MFN 05-127

Subject: **NEDO-33083-A, "TRACG Application for ESBWR," October 2005
(TAC # MC8168)**

TRACG Application for ESBWR

Figure 187A GDCS Equalization Line

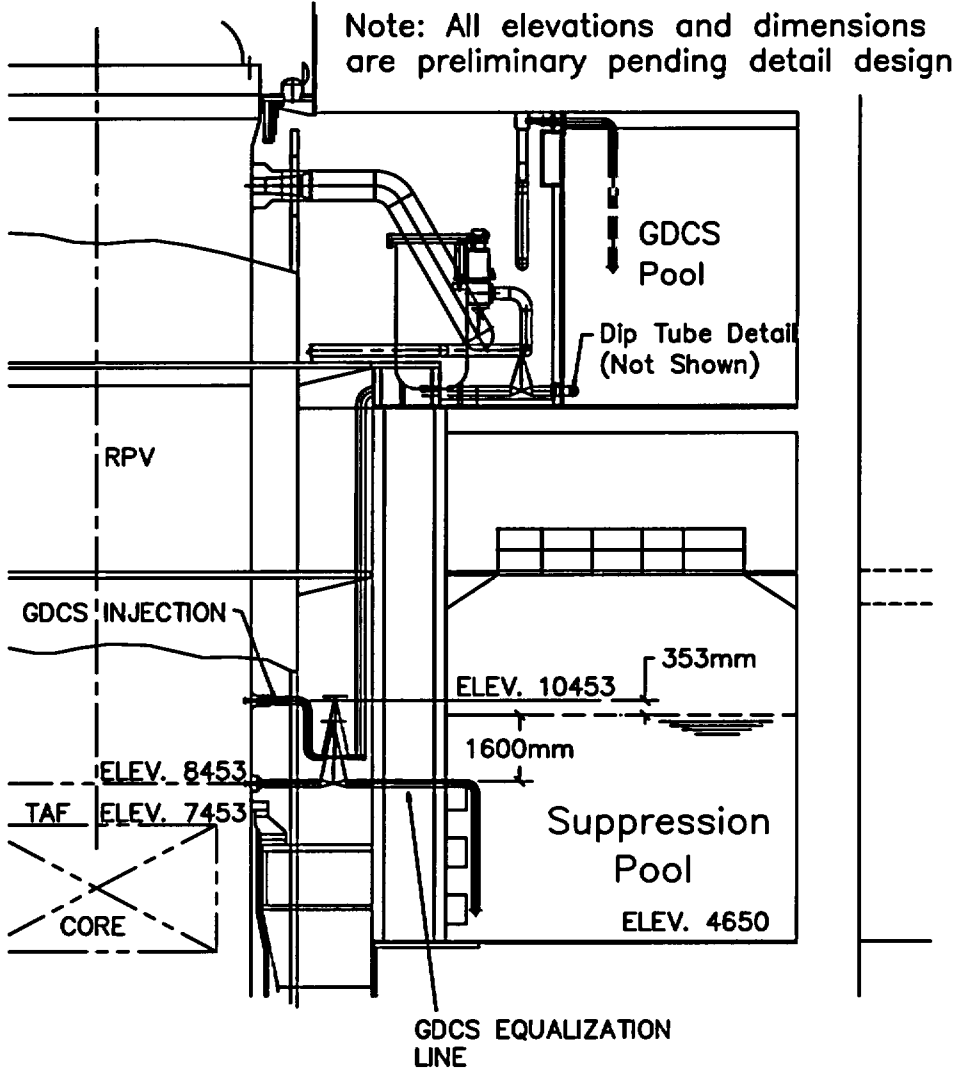
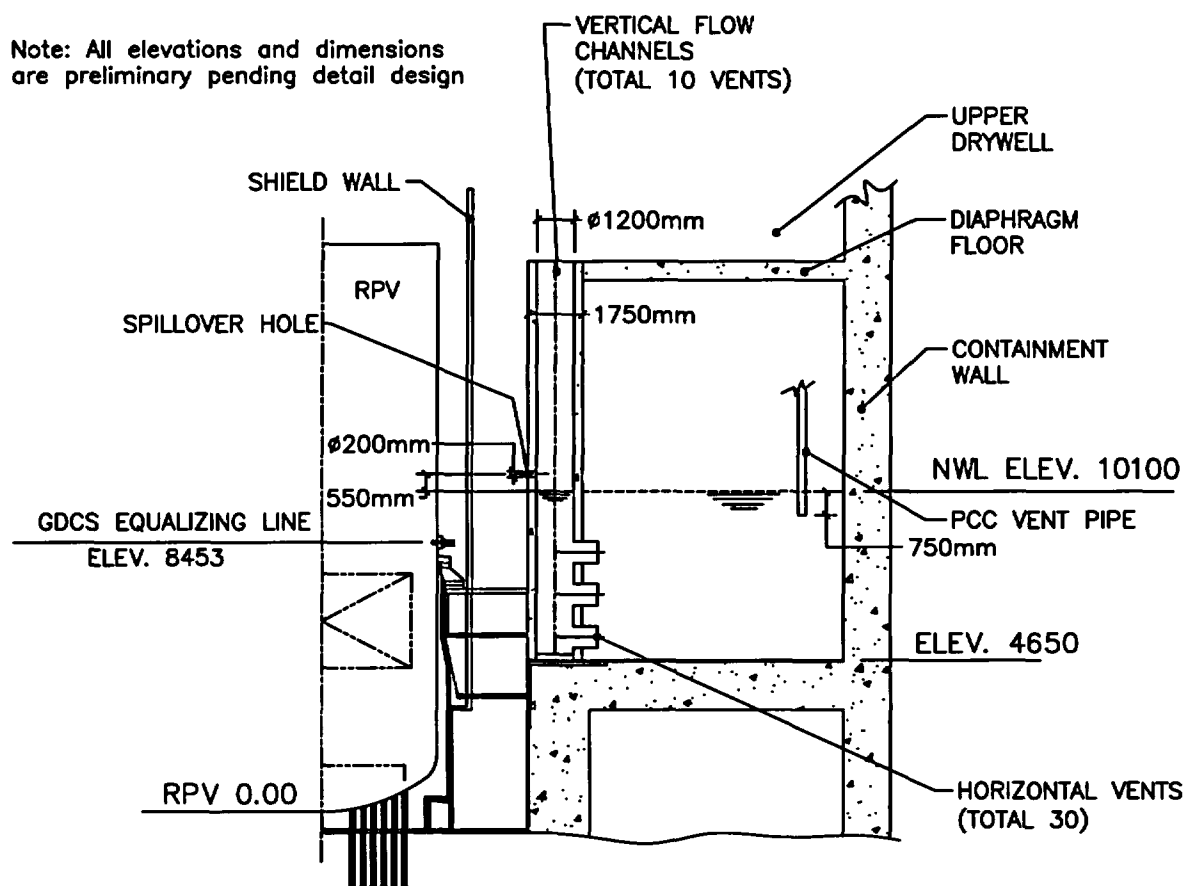
R187. Please see Figure 187A and Figure 187B for details.

Figure 232 -1

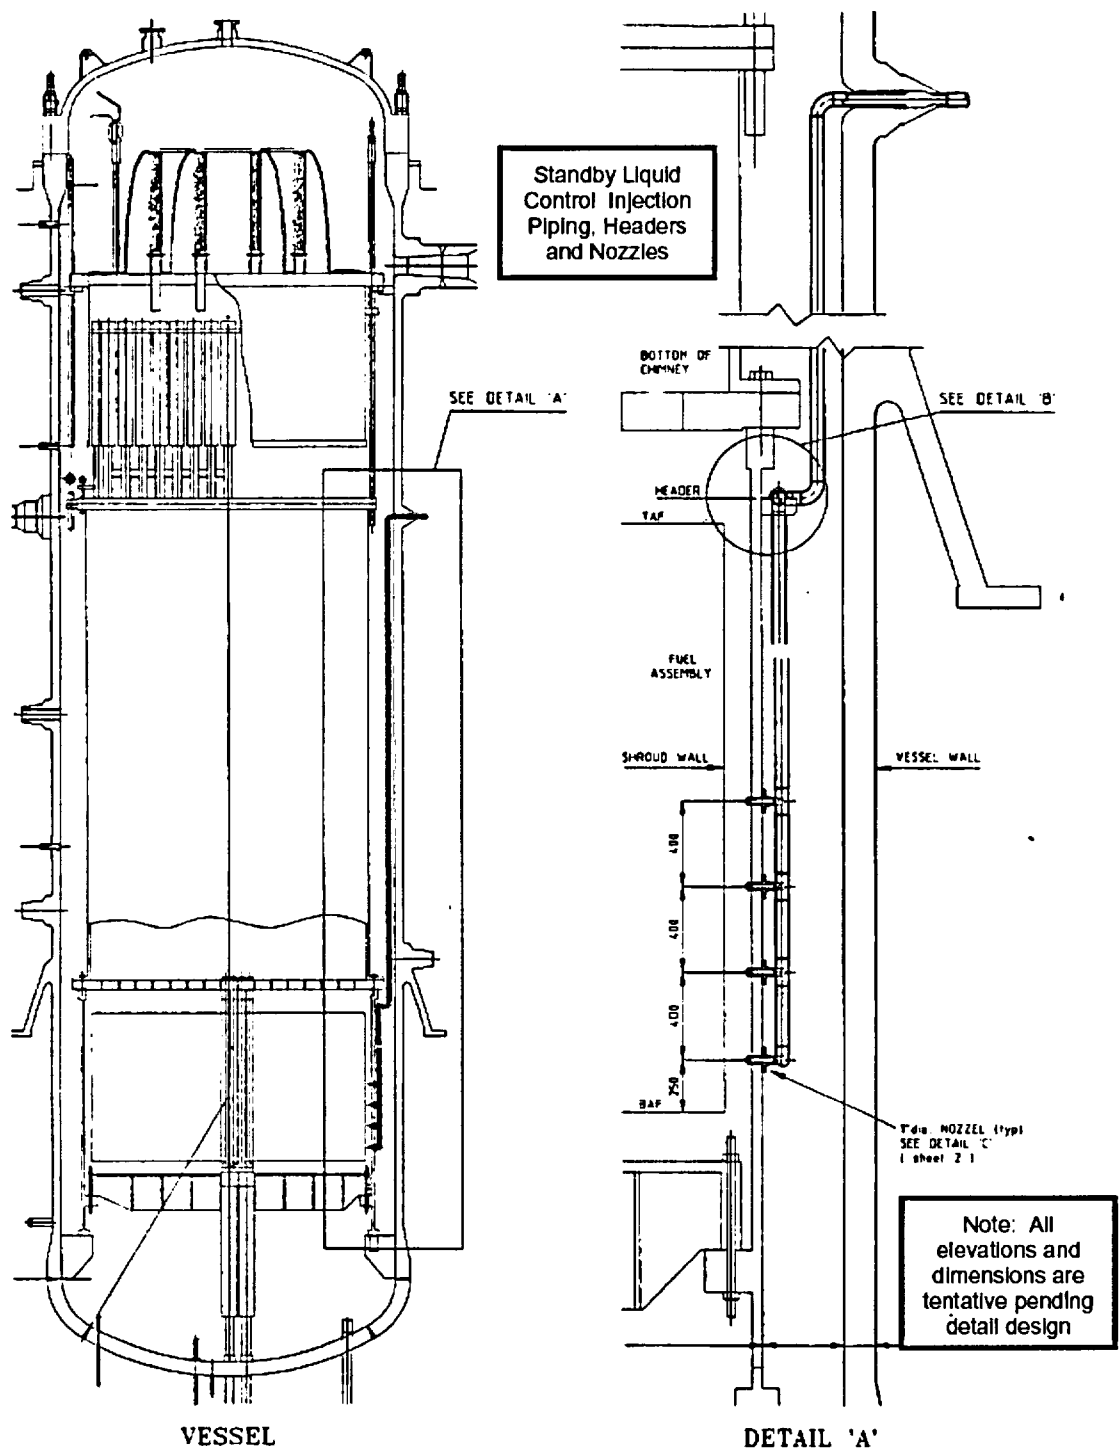
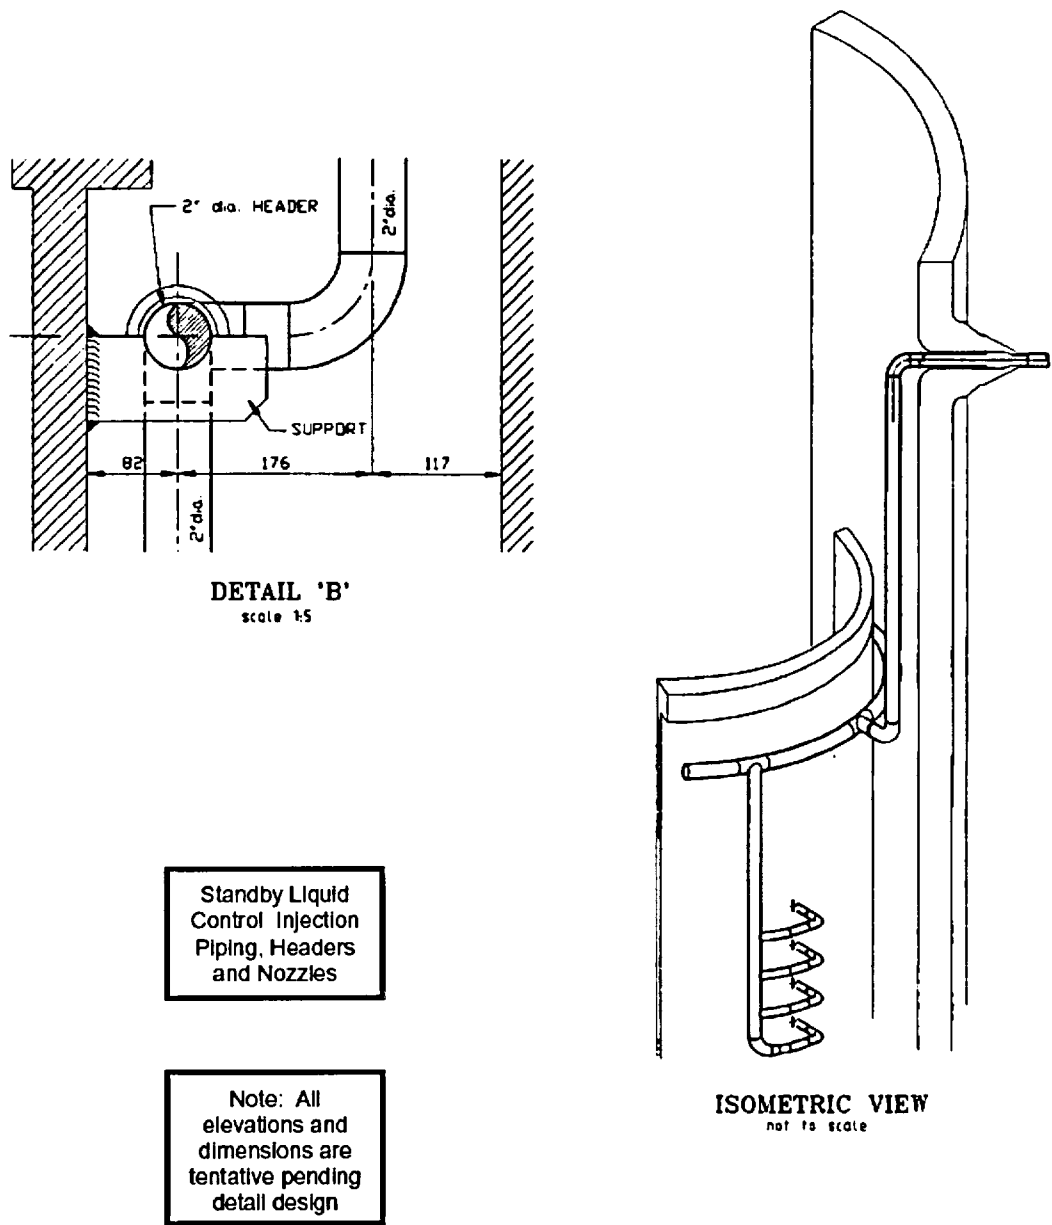
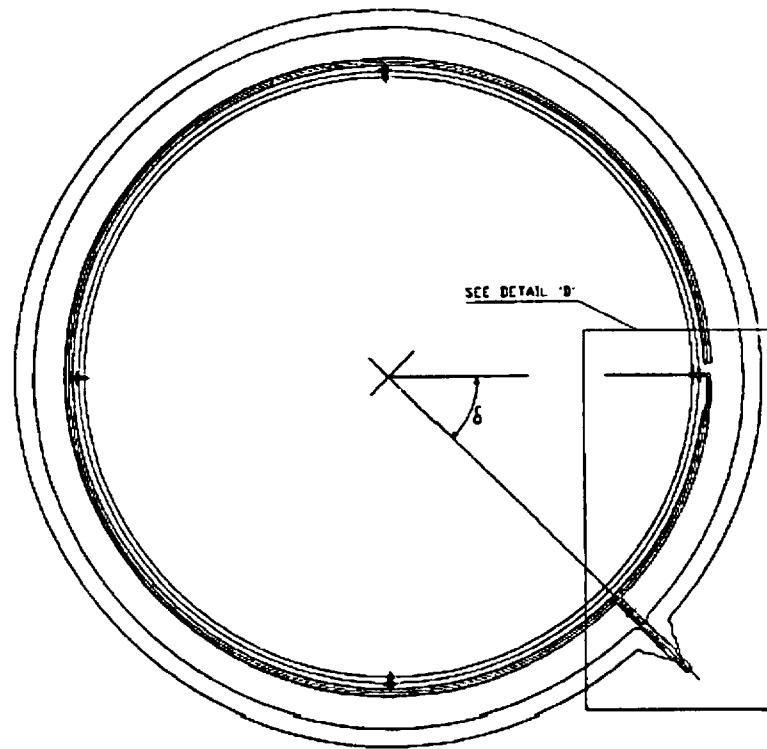
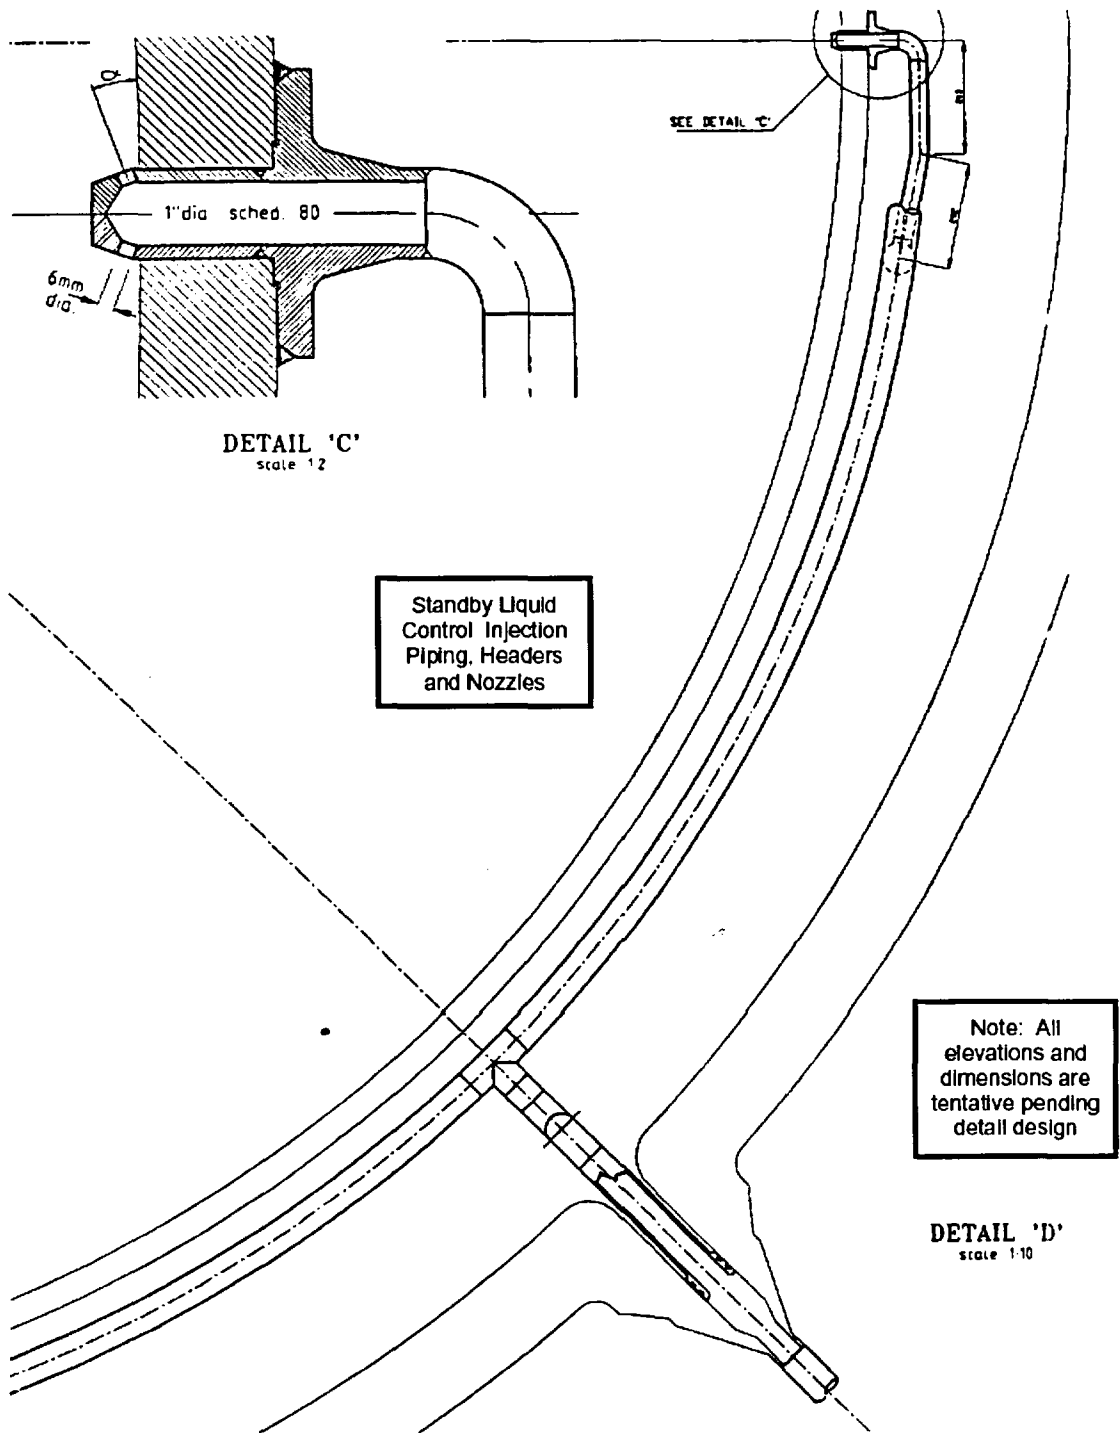
R232. The SLCS injects poison directly through the core shroud into the core bypass region. There are four azimuthal locations and four axial locations as shown in Figures 232.1 through 232.4. The dimensions and elevations as shown in the four figures are preliminary and may change during final design.
